Gachsaran Polymer Industries Company	Gachsaran Polymer Industries Company HDPE Plant		
	General Arrangement Drawing (2D) (*Tie-In Points , Skid Dimensions & Orientation, Including Instrument, Junction Box and Local Panel Location Layout & Instrument Cable routing.) for Refrigerator Package	 	
PO No.: GPIC-PT-MA-PO-000-3029	Document Number: VD-GPIC-MA-3029-3029-0062	Rev. 01	Page 1 of 10

General Arrangement Drawing (2D) (*Tie-In Points , Skid Dimensions & Orientation, Including Instrument, Junction Box and Local Panel Location Layout & Instrument Cable routing.) for Refrigerator Package

DRAWING NO.	REV.	SHEET NO.	SIZE
VD-GPIC-MA-3029-3029-0062	01	3 OF	A1

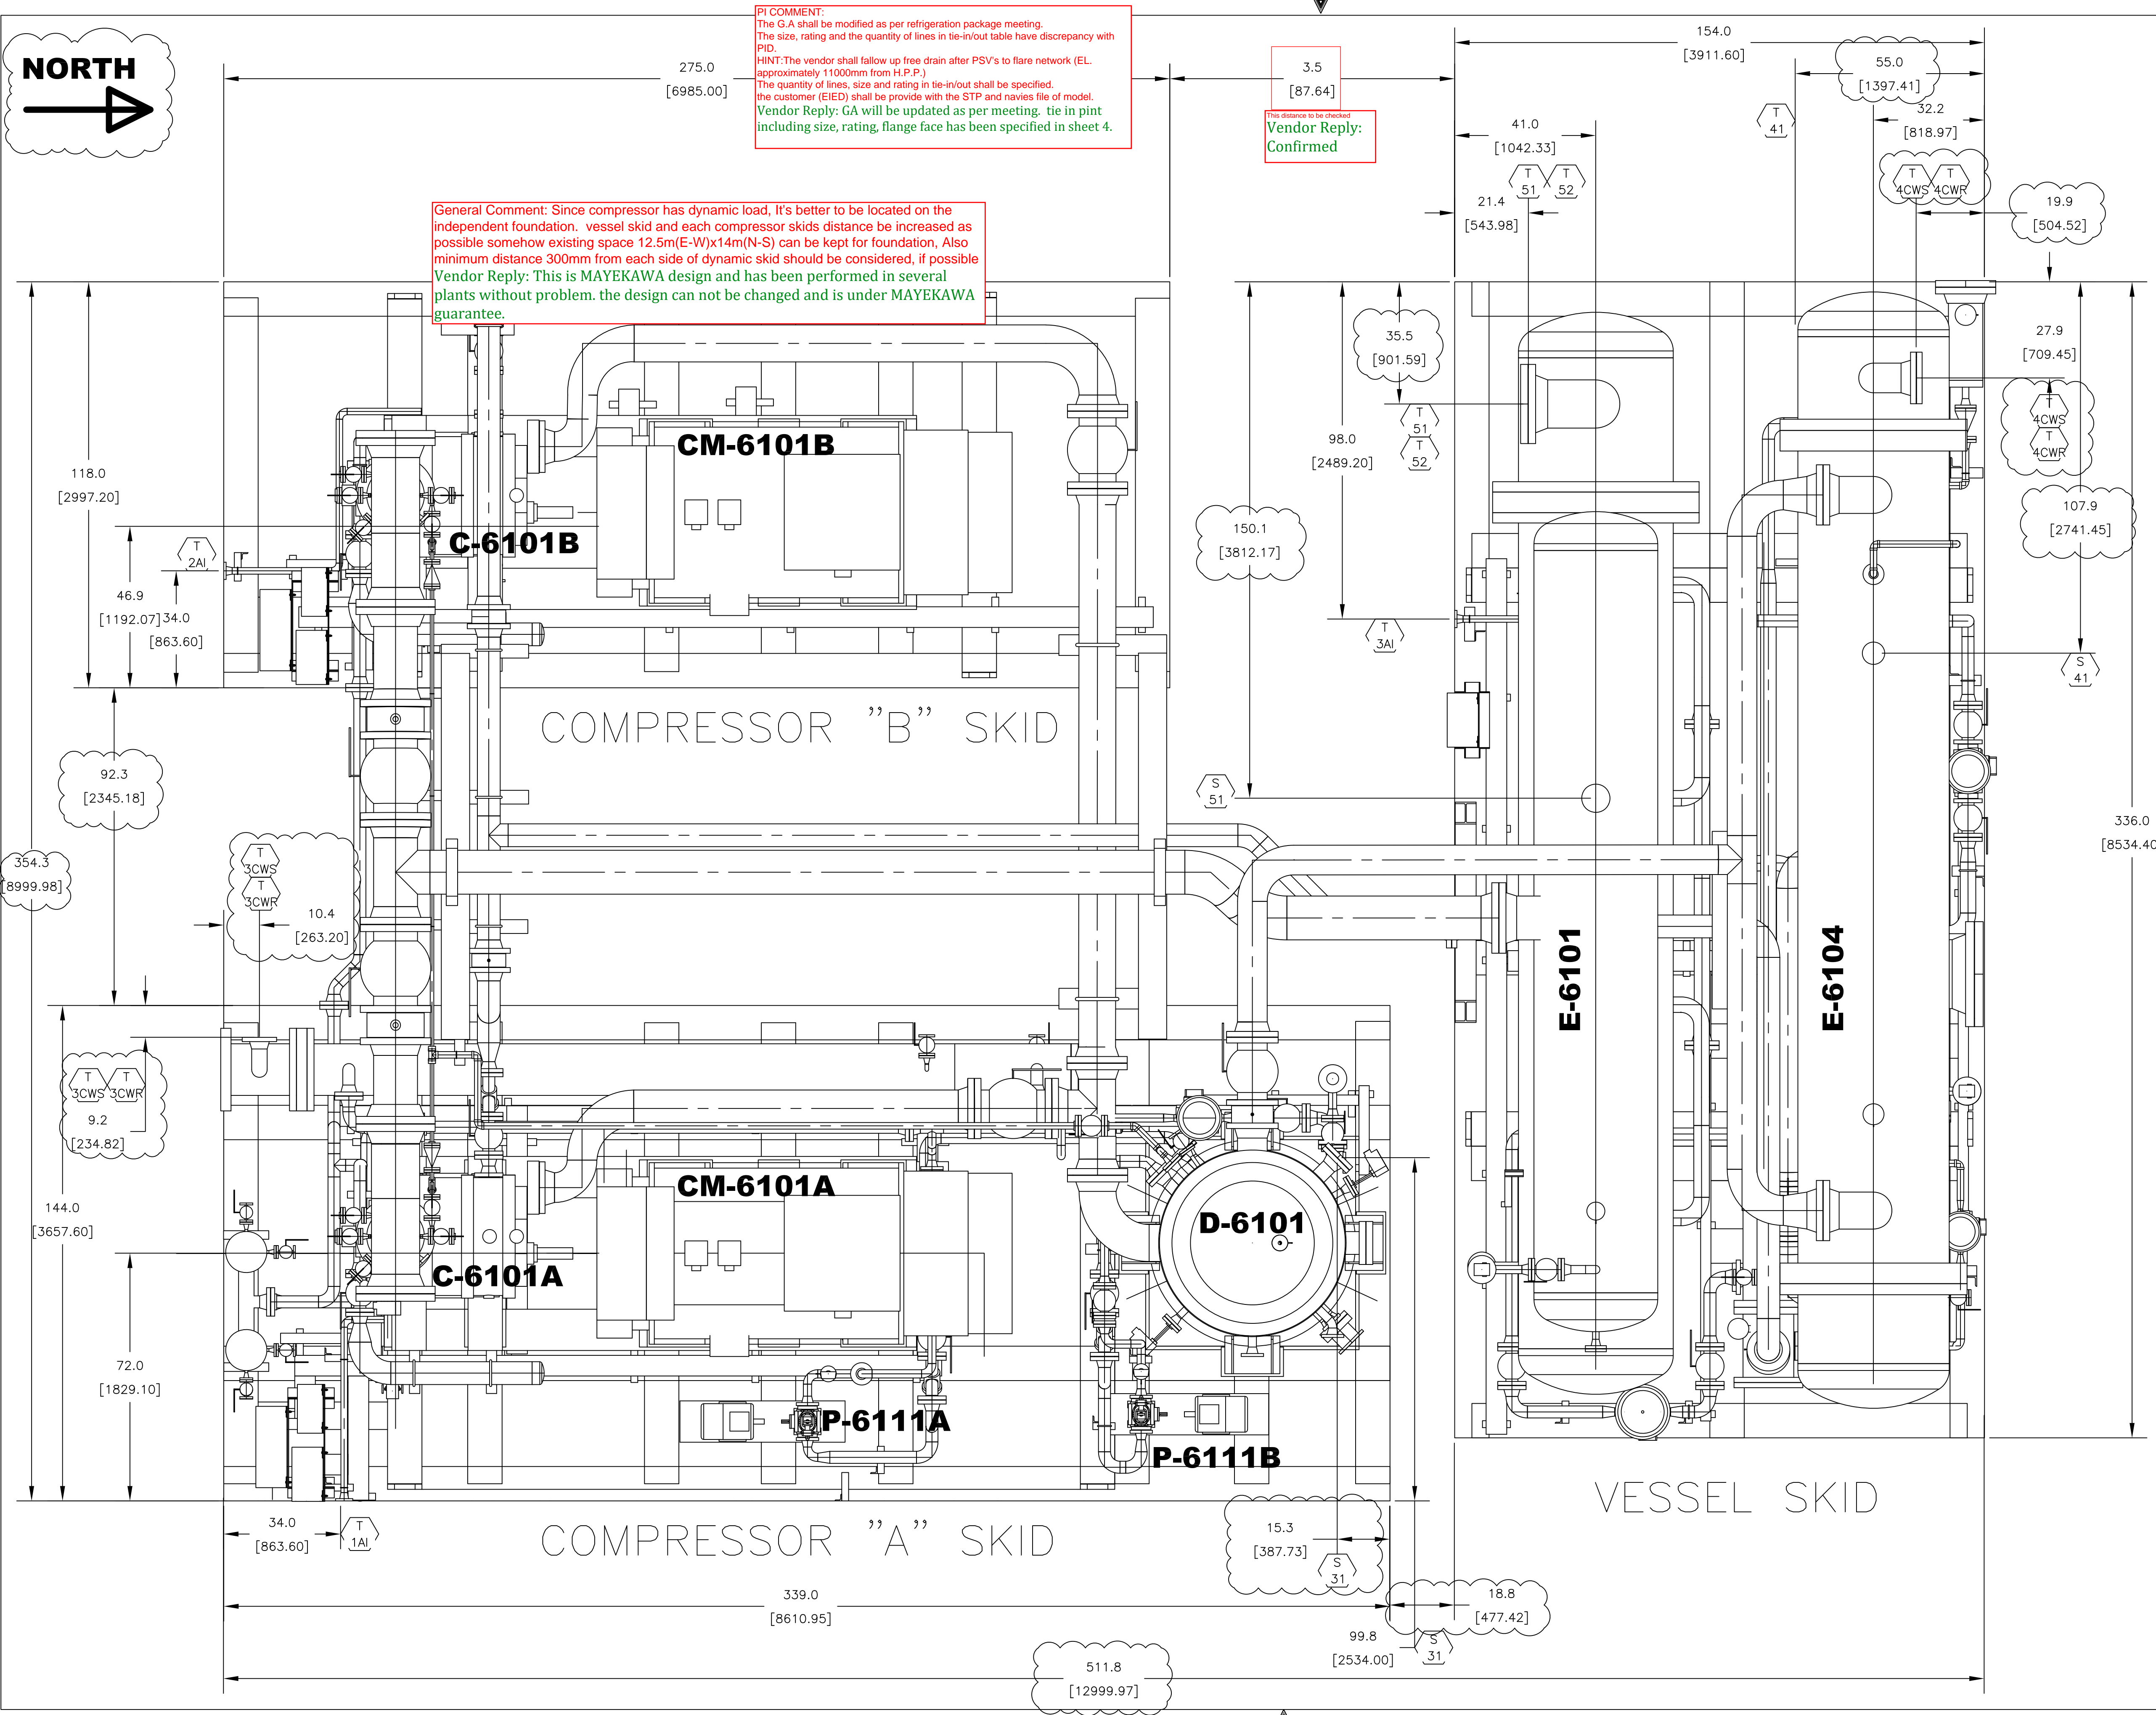
PI COMMENT:
 The G.A shall be modified as per refrigeration package meeting.
 The size, rating and the quantity of lines in tie-in/out table have discrepancy with PID.
HINT: The vendor shall follow up free drain after PSV's to flare network (EL. approximately 1100mm from H.P.P.)
 The quantity, lines, size and rating in tie-in/out shall be specified.
 The customer (EIED) shall provide with the STP and navies file of model.
Vendor Reply: GA will be updated as per meeting, tie in pint including size, rating, flange face has been specified in sheet 4.

General Comment: Since compressor has dynamic load, it's better to be located on the independent foundation. vessel skid and each compressor skids distance be increased as possible somehow existing space 12.5m(E-W)x14m(N-S) can be kept for foundation, Also minimum distance 300mm from each side of dynamic skid should be considered, if possible
Vendor Reply: This is MAYEKAWA design and has been performed in several plants without problem. the design can not be changed and is under MAYEKAWA guarantee.

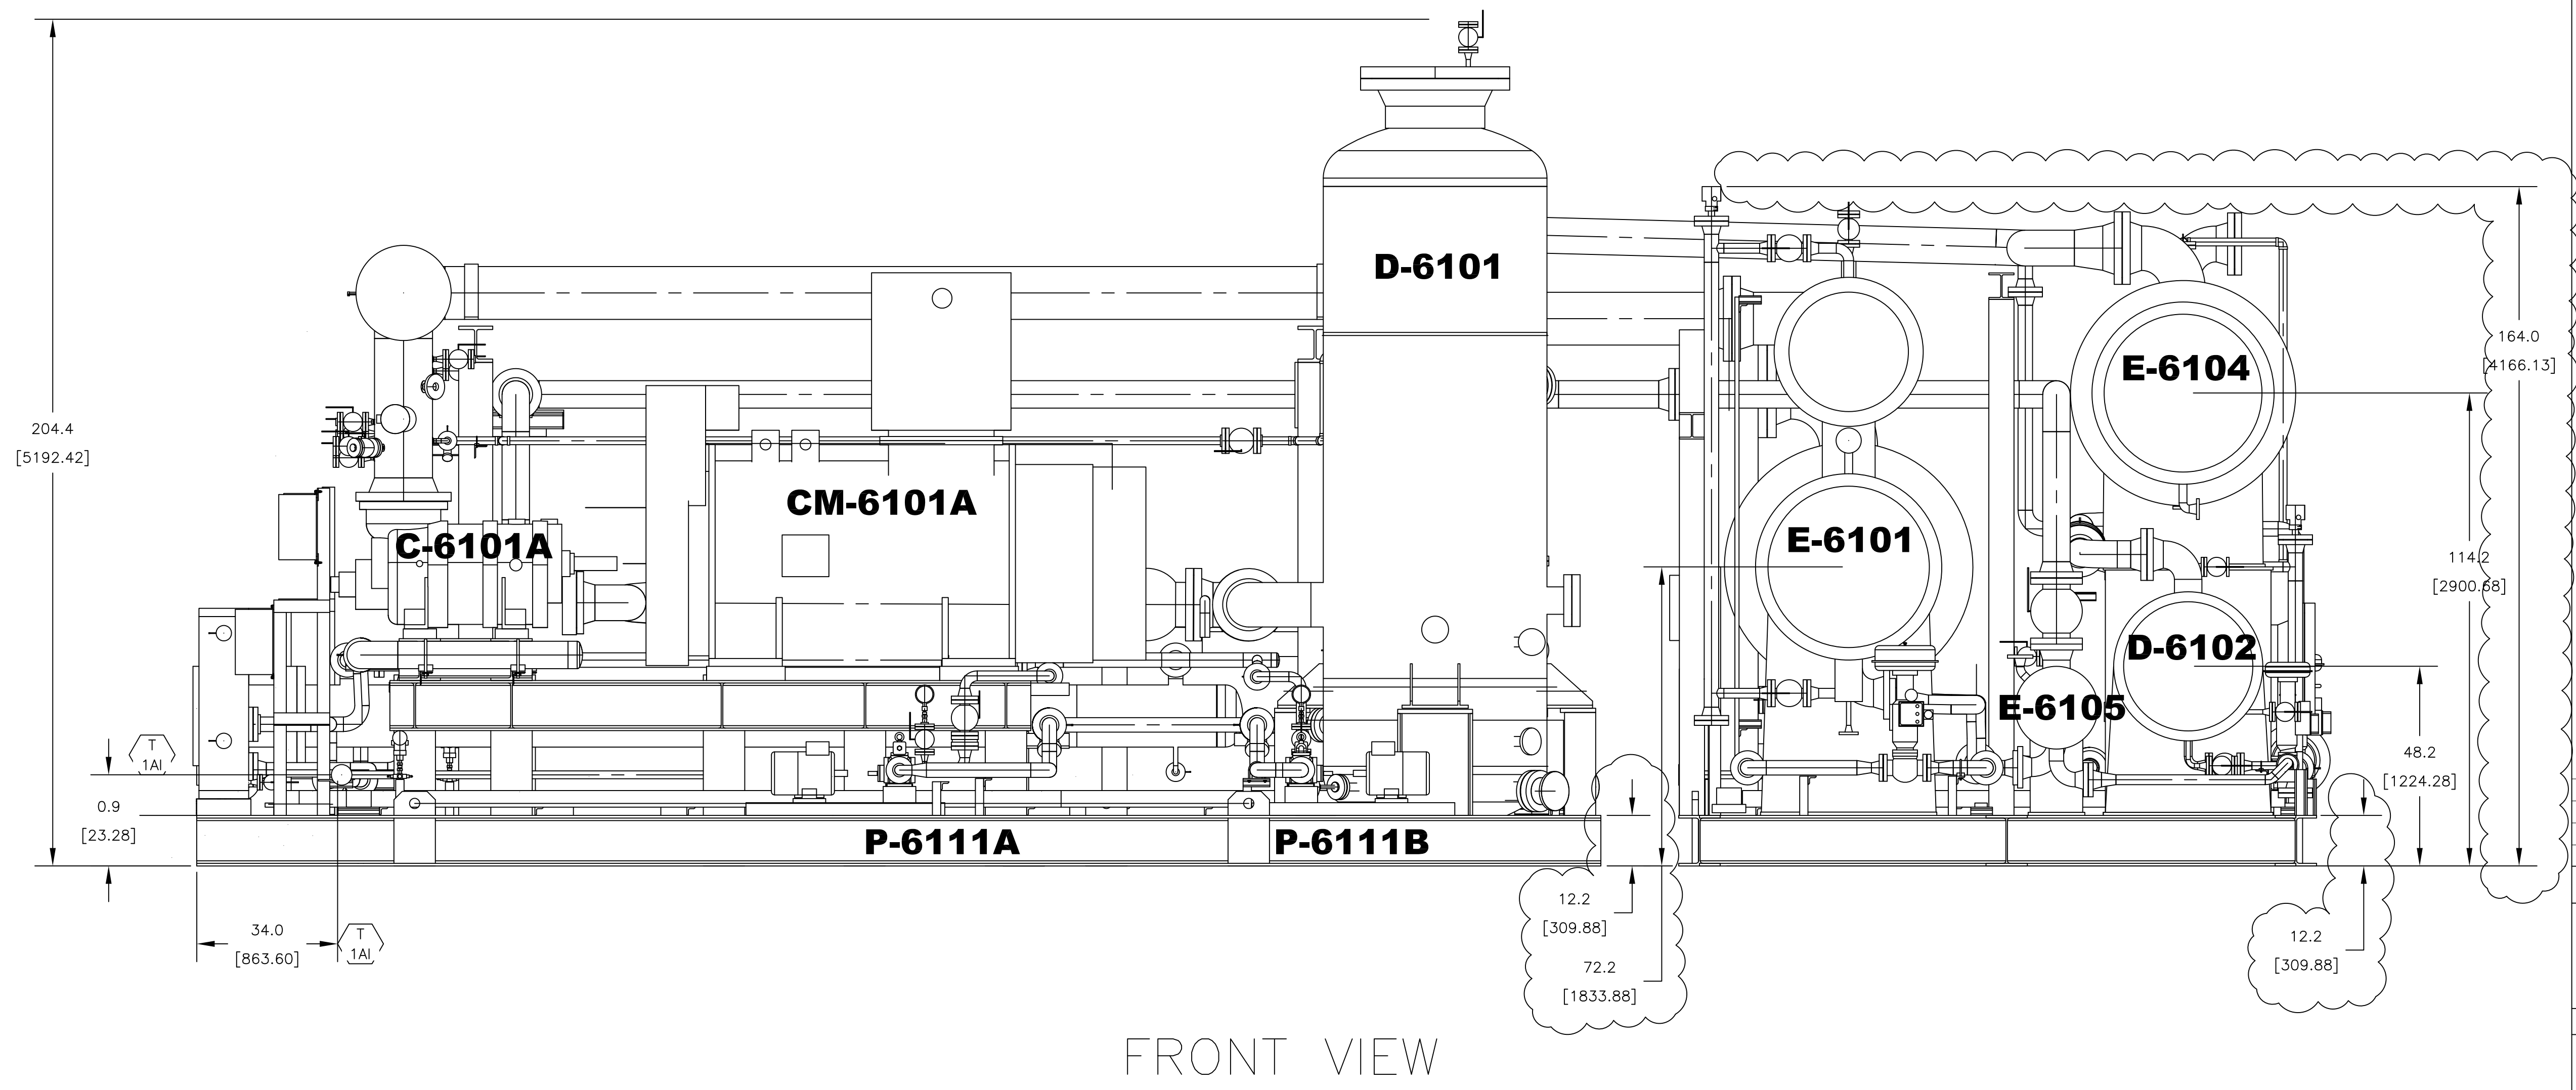
EL01: Local Panel and junction boxes shall be numbered and displayed in a table with tags.
 Vendor Reply: Noted. JB's and LCP's TAG number will be added to the table

Vendor Shall confirm:
 Gasket contact surface finish for raised or flat faces Flanges, Blind Flanges, Spades, and Spectacle Blinds, shall be finished in accordance with ASME B16.5, concentric or spiral serrated (125-250 µin. AARH) and for RJ flanges as per 63 µin. AARH.
 Vendor Reply: Confirmed

DRAWING NO.	REV.	SHEET NO.	SIZE
VD-GPIC-MA-3029-3029-0062	01	5 OF	A1

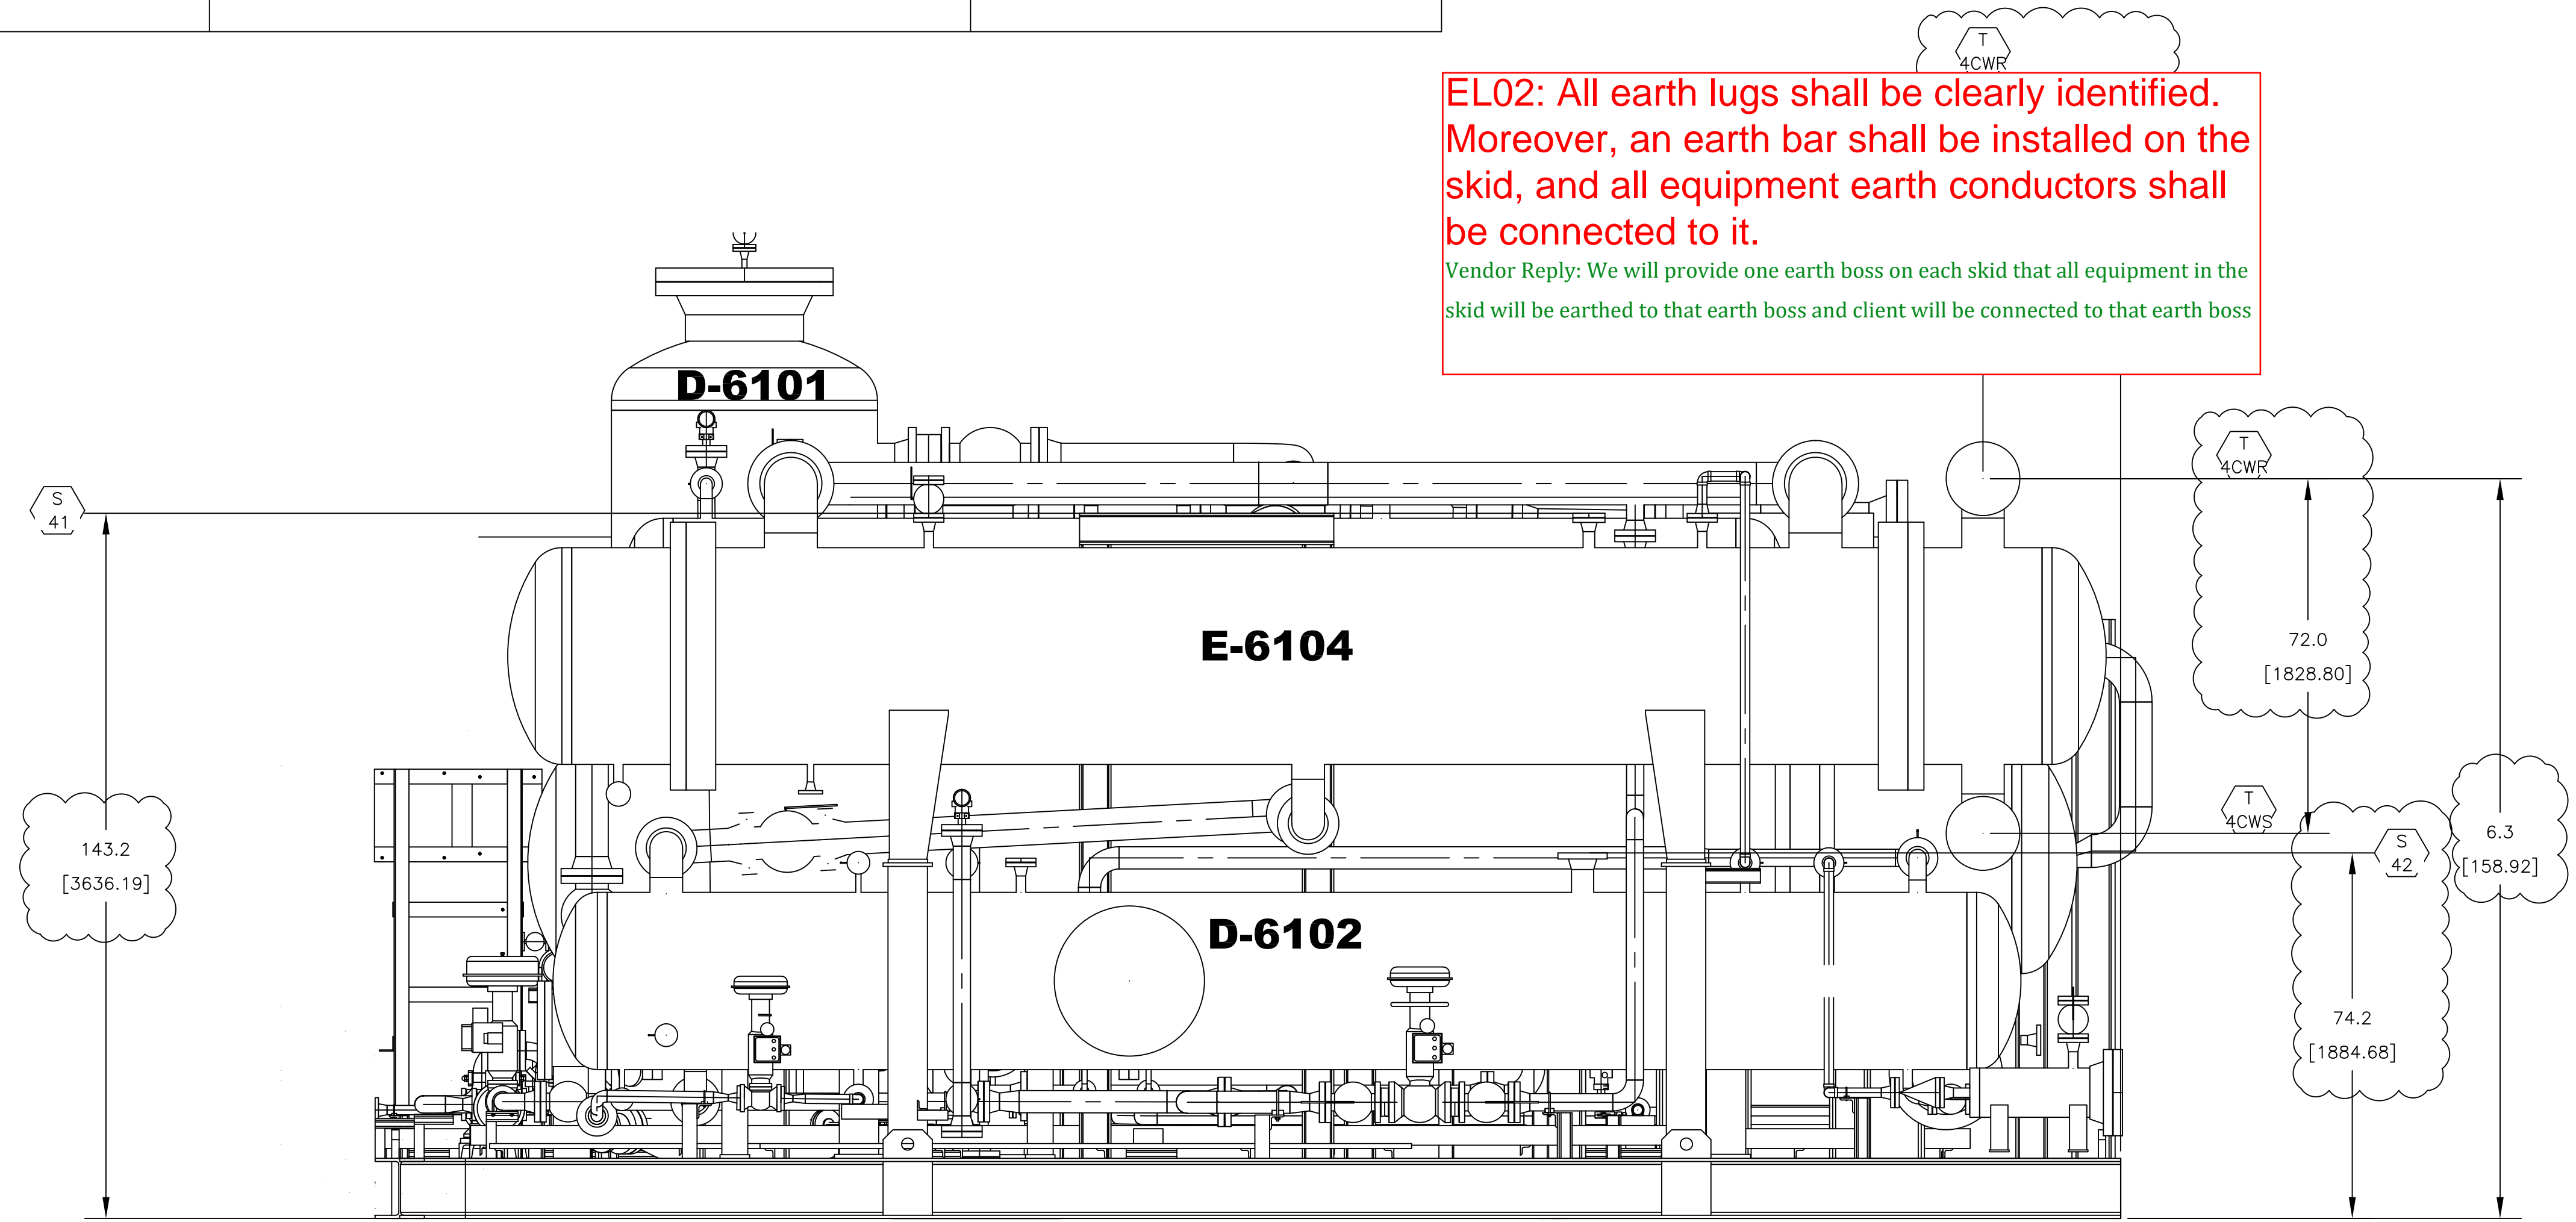
EL02: All earth lugs shall be clearly identified. Moreover, an earth bar shall be installed on the skid, and all equipment earth conductors shall be connected to it.
 Vendor Reply: We will provide one earth boss on each skid that all equipment in the skid will be earthed to that earth boss and client will be connected to that earth boss
